ASOS MODIFICATION NOTE 50 (for Electronics Technicians)

SUBJECT : Automated Surface Observing System (ASOS) Voice Processor Board (VPB), 1A2A20, Firmware Version 4.0 Upgrade

PURPOSE : To add additional Meteorological Aviation Report vocabulary to the ASOS.

Figure 1 Voice Processor Board (1A2A20)

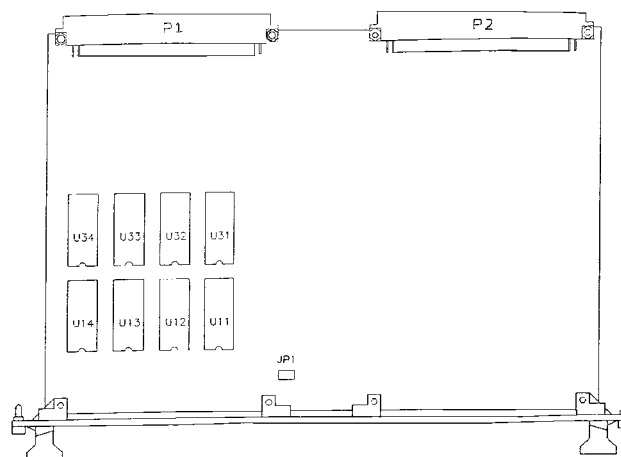
The instructions, for this modification note, describe the removal and installation of EPROMs U32-U34, on the VPB, 1A2A20. (Refer to figure 1). If installing in conjunction with Modification Note 47, complete steps 3-12 under ASOS VPB EPROMS installation.

6. Using the IC extraction tool, remove the U32 EPROM from the front of the board slide. Carefully lift up on U32 to remove it from the socket as evenly as possible. After U32 is removed from the socket, place in a conductive foam or on some other static-free surface. (Refer to figure 1 for IC locations).

7. Repeat step 6 for the removal of ICs U33 and U34.
8. Remove the new EPROMs, for firmware 4.0, from the protective package and insert them into the VPB sockets in accordance with the chart below. Using the IC insertion tool and ensuring the EPROMs are installed with pin 1, as identified by the notch in the top of IC, press the EPROMs into their respective sockets.

<u>IC socket</u>	<u>IC Part number</u>
U32	45015
U33	45016
U34	45017
